SERVICE BULLETIN**SB16-7**

SUBJECT: Hartzell Engine Technologies (HET) Service Bulletin (SB) No. 067

Service Bulletin No. 067

Turbocharger Wastegate Poppet Valve Replacement HET Part Number 477285-0002

Figure 2 - New Poppet Valve (HET P/N 477285-0002) with H1112 Date Code

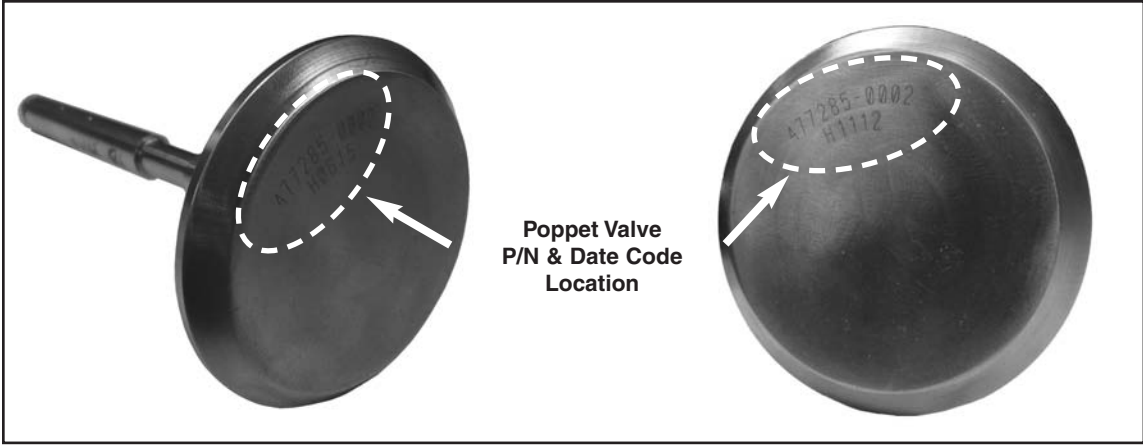
- (1) Remove the affected Wastegate Poppet Valve assembly from the Turbocharger in accordance with the aircraft/engine and the HET 400600-0000 Rev B or latest maintenance manuals.
- (2) Inspect the face of the Poppet Valve for the affected date code (H1112) shown in Fig. 2:
 - (a) If the date code is H1112, continue to 3.C(1) or 3.C(4).
 - (b) If the date code is not H1112, continue to 3.D.
- (3) If the date code can not be determined, place a magnet on the valve face similar to that shown in Fig. 4.
 - (a) If the magnet sticks to the Poppet Valve, it is an affected Poppet Valve. Continue to 3.C(1) or 3.C(4).
 - (b) If the magnet does not stick to the Poppet Valve, it is not an affected. Continue to 3.D.

Figure 3 - Corroded Poppet Valve Examples

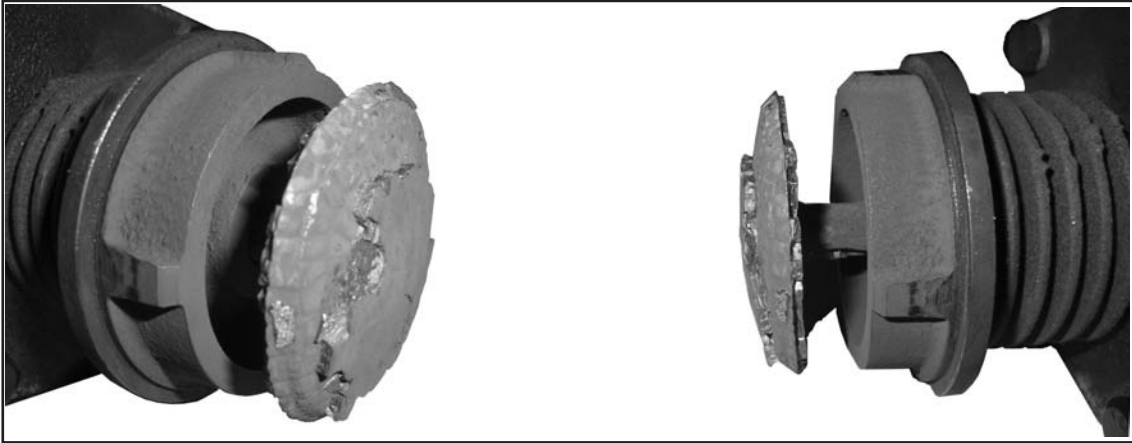
- (1) Affected serial numbers of Wastegate Poppet Valve assembly HET P/N 470892-0002 or P/N 470892-9002 and CMI P/N's 635381-2 or R-635381-2 as installed in Turbochargers listed in 1.A(1) have poppet valve P/N 477285-0002 that may exhibit excessive corrosion during normal operation.

- (2) Corrosion of the Wastegate Poppet Valve may result in a slow loss of manifold pressure due to leakage past the corroded valve and may require replacement of the Poppet Valve.
- (3) Affected Poppet Valves P/N 477285-0002 must be replaced with a Poppet Valve that is not affected by this Service Bulletin.
- (4) Regulatory action is unknown.
